Planning Commission

Columbia Chevrolet – Final Development Plan Approval 9750 Montgomery Road

September 17, 2021

JOSEPH AUTOMOTIVE COLUMBIA CHEVROLET LOT EXPANSION SITE PLAN

PLANT SCHEDULE MONTGOMERY RD FRONTAGE

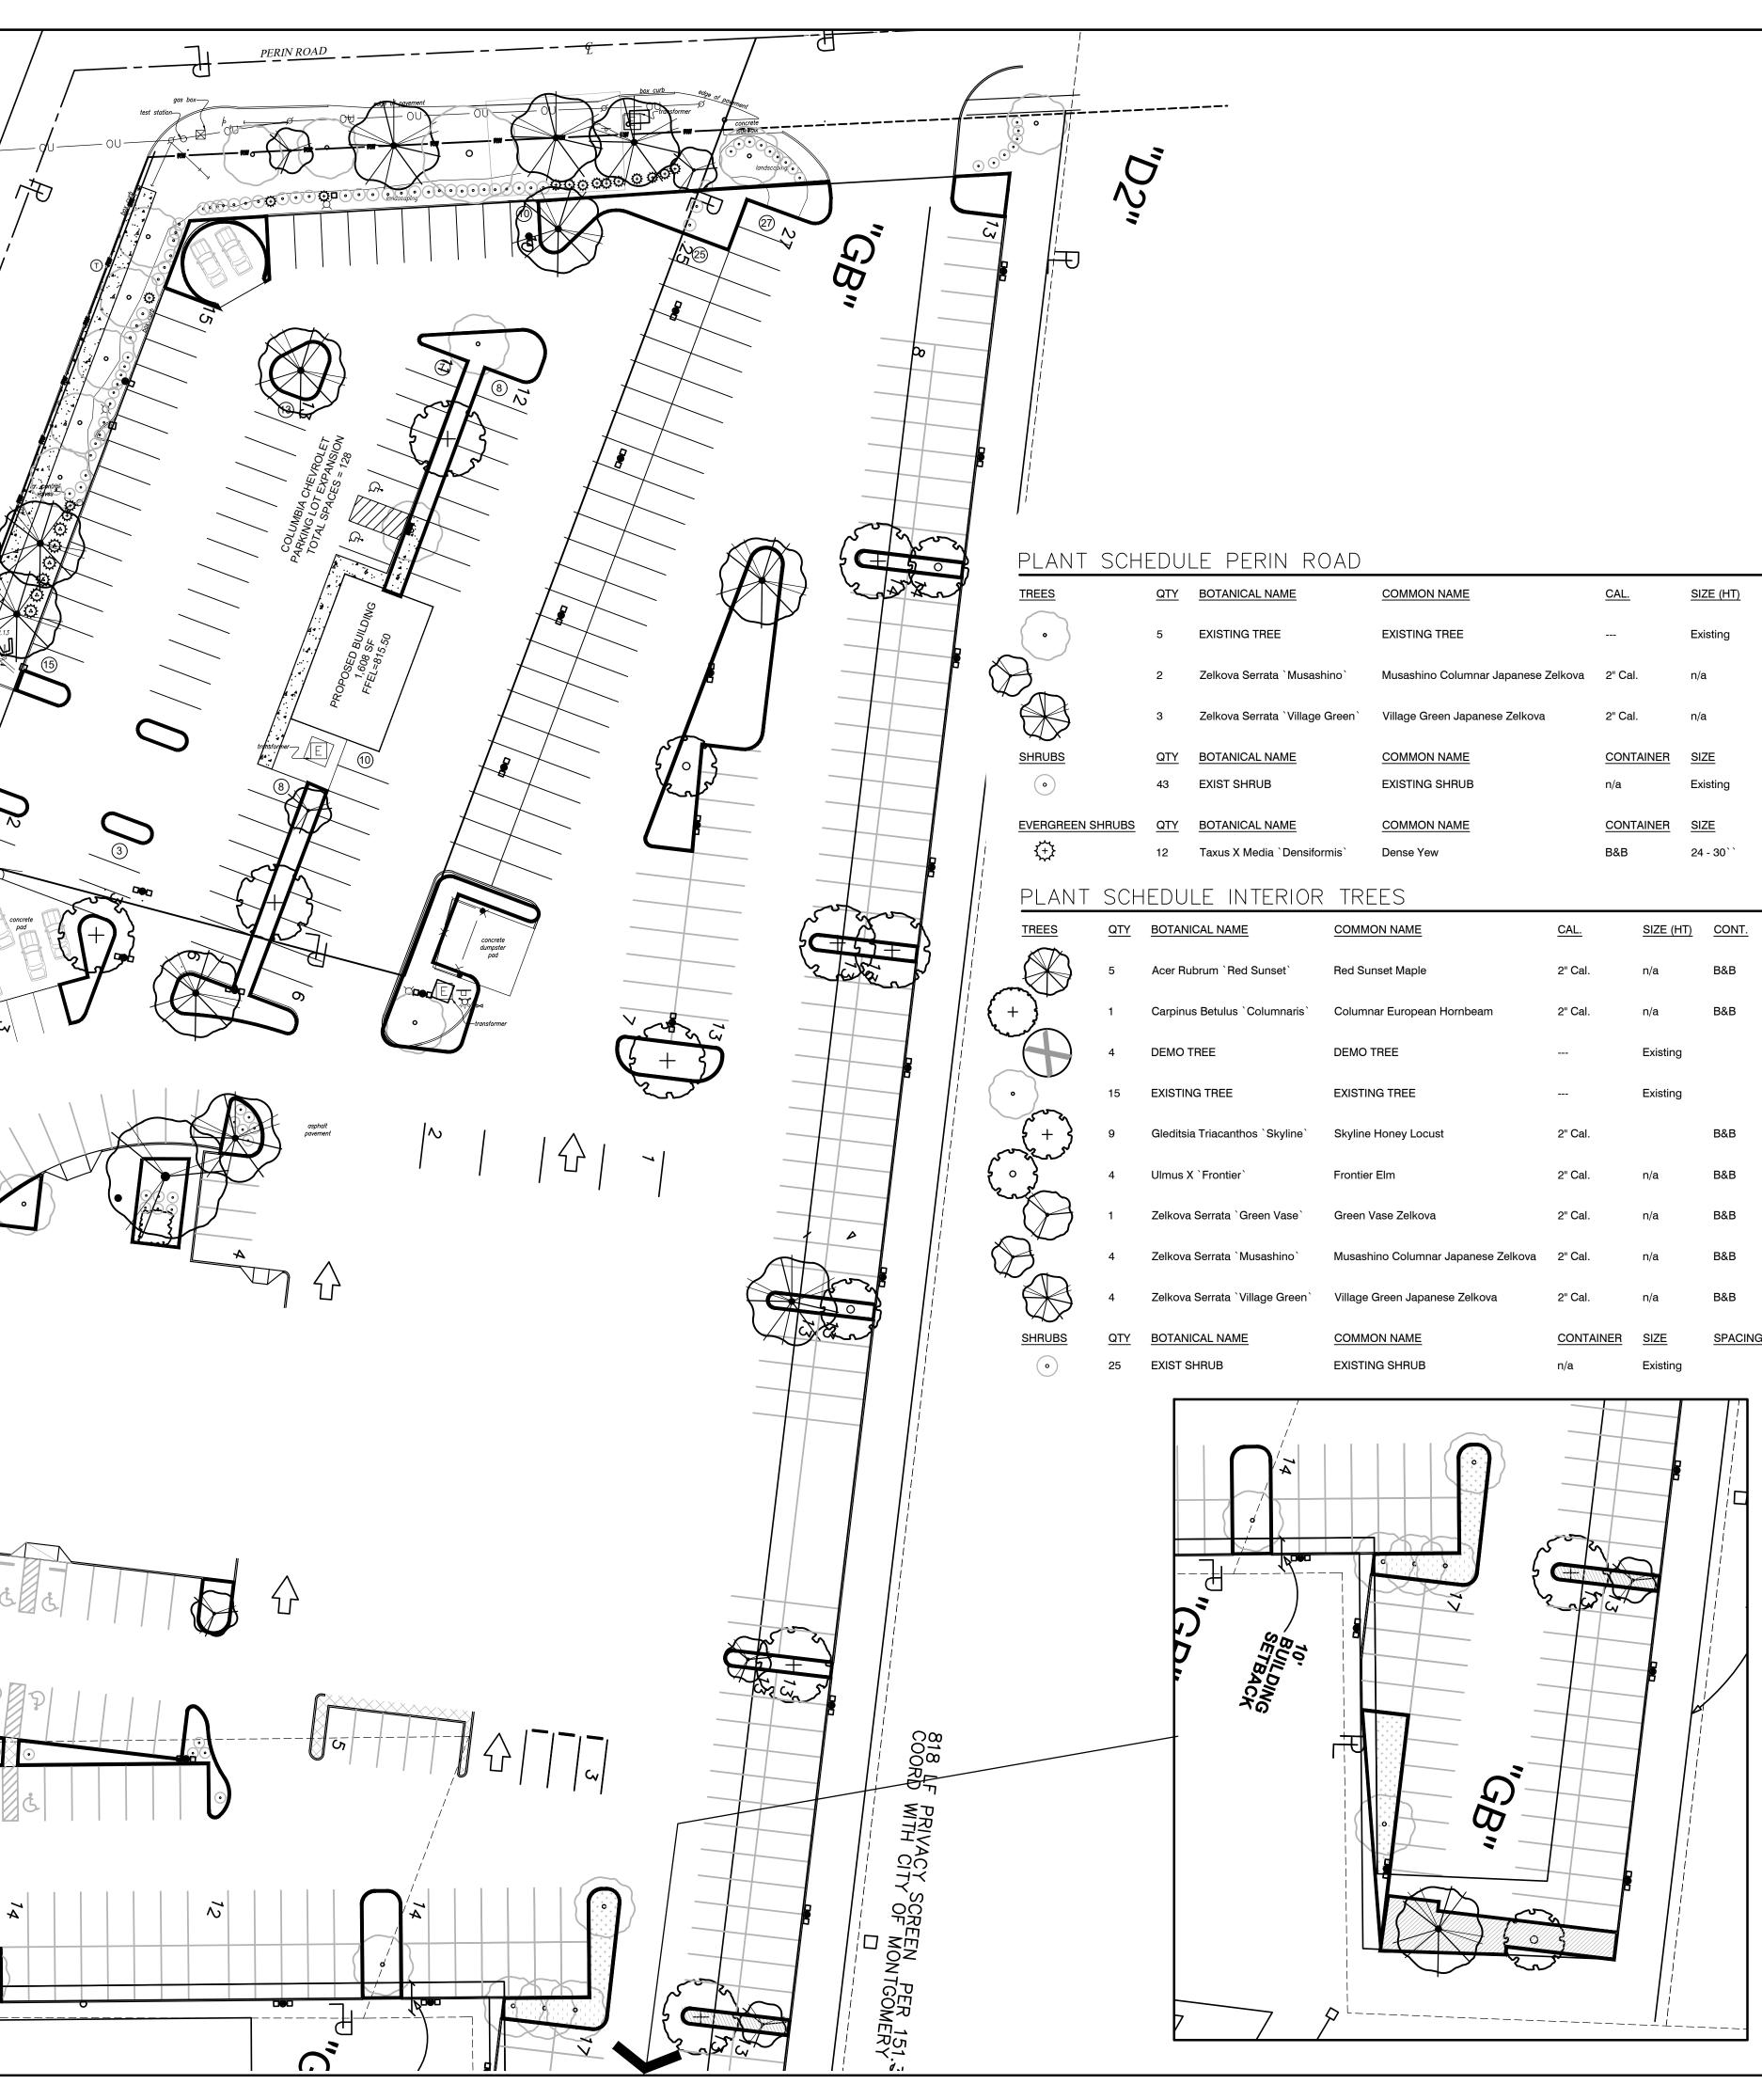
Landscaping: The applicant has provided a landscape plan that includes perimeter and interior parking lot landscaping. The proposed landscaping for the project meets the standards for interior parking lot landscaping and perimeter parking lot landscaping. The majority of the existing landscape on the former Steak 'n Shake site and the Chevrolet site will be maintained, and additional perimeter and interior parking lot landscaping will be added to bring the project into compliance with the landscaping requirements. A total of five trees and two shrubs will need to be removed to construct the project.

A total of 8 trees (Red Sunset Maple and Skyline Honey Locust) and 22 shrubs (Grey Owl Juniper and Dense Yew) will be added to meet the perimeter landscaping requirements for the project. A total of 28 trees will be added to meet the interior parking lot requirements. The additional interior parking lot trees include Red Sunset Maple, Columnar European Hornbeam, Skyline Honey Locust, Frontier Elm, Green Vase Zelkova and Japanese Zelkova. A total of 10% interior parking lot landscaping is provided, which meets the requirement established in Section 151.3408(A)(1). The plan has been reviewed and approved by the City Arborist.

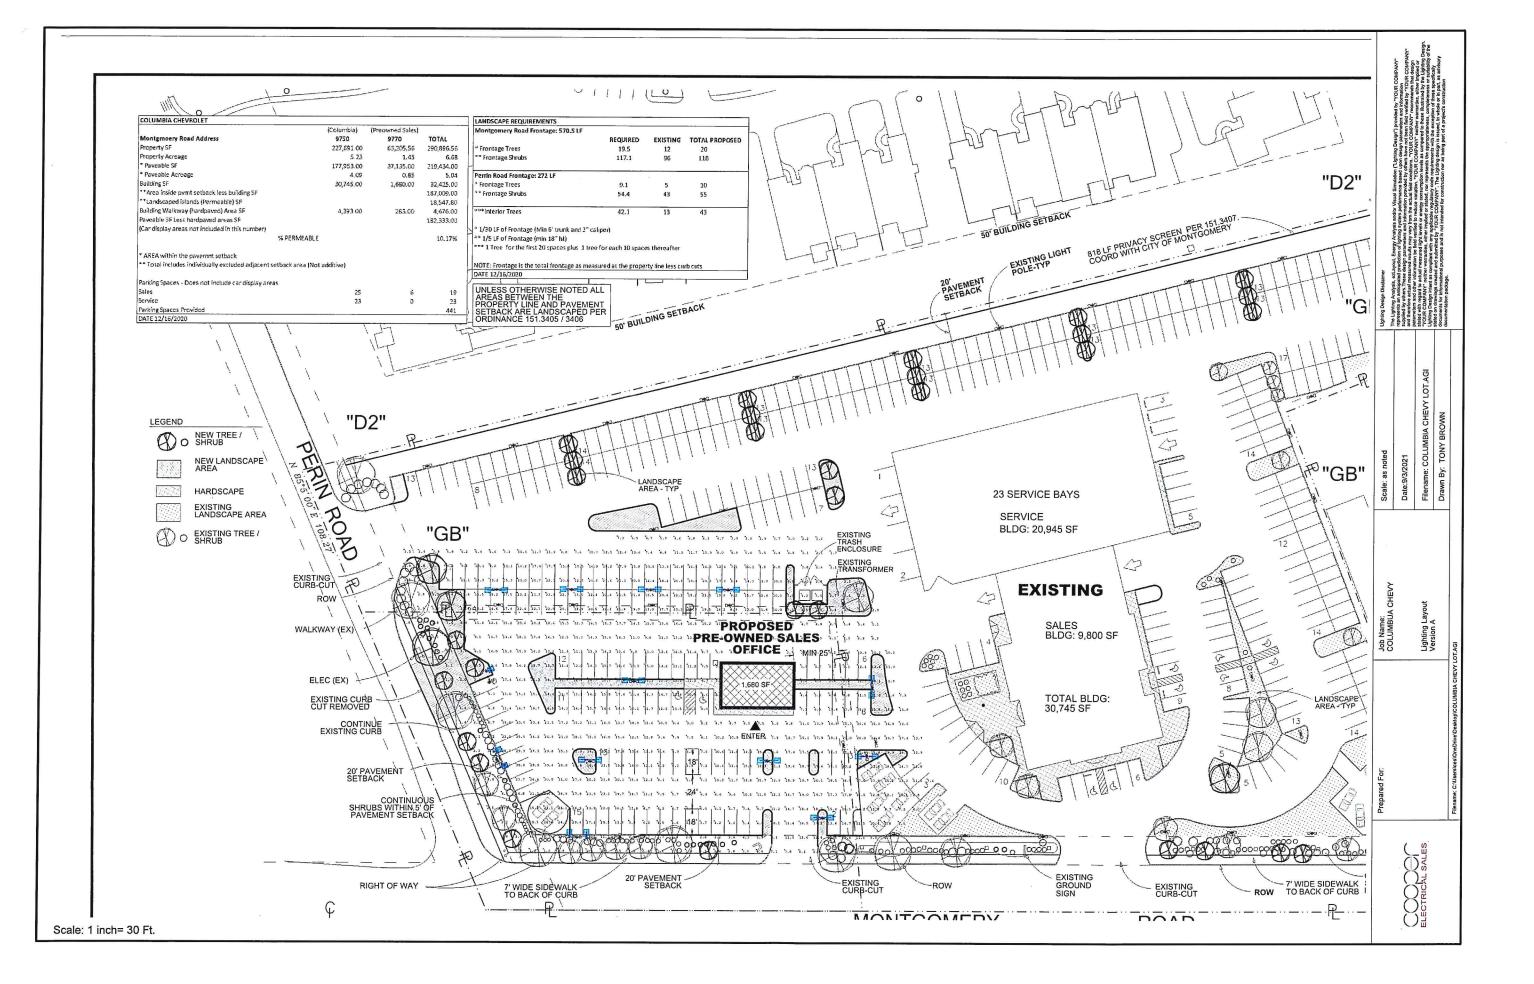
Lighting: Thirteen additional light poles will be required on the property located at 9770 Montgomery Road (former Steak 'n Shake site). The new poles and fixtures would match existing poles on the Chevrolet site, which comply with the Zoning Code. Staff has reviewed the provided photometric plan and found that it is general compliance with the Zoning Code regulations. The average footcandles shown on the plan is 11.56 fc, which is in compliance with the average permitted 12fc. However, the Zoning Code requires that the overnight average illumination be reduced to 10fc for the front row and feature display areas and to 3fc for the balance of the display/storage areas, which has not been addressed in the plans. Staff would recommend that the applicant work with Staff to ensure that the lighting complies with the zoning regulations in the overnight hours.

Staff believes that the issues with the Final Development Plan is very well done, and any issues can be managed via conditions, specifically the clarification required for the photometric plan.

- 1. All conditions approved by the Planning Commission and City Council for the expansion of a conditional use and General Development Plan with an equivalency shall apply.
- 2. The final stormwater, grading and utility plans shall be approved by the City Engineer.
- 3. The final design for the sidewalk shall be reviewed and approved by the City Engineer and the Public Works Director.
- 4. The Final Photometric Plan be reviewed and approved by the Community Development Director prior to issuing any building/zoning permits.
- 5. All light poles to be put on a timer to reduce the average footcandles in the overnight hours as required by Schedule 151.3213(C)(ii).
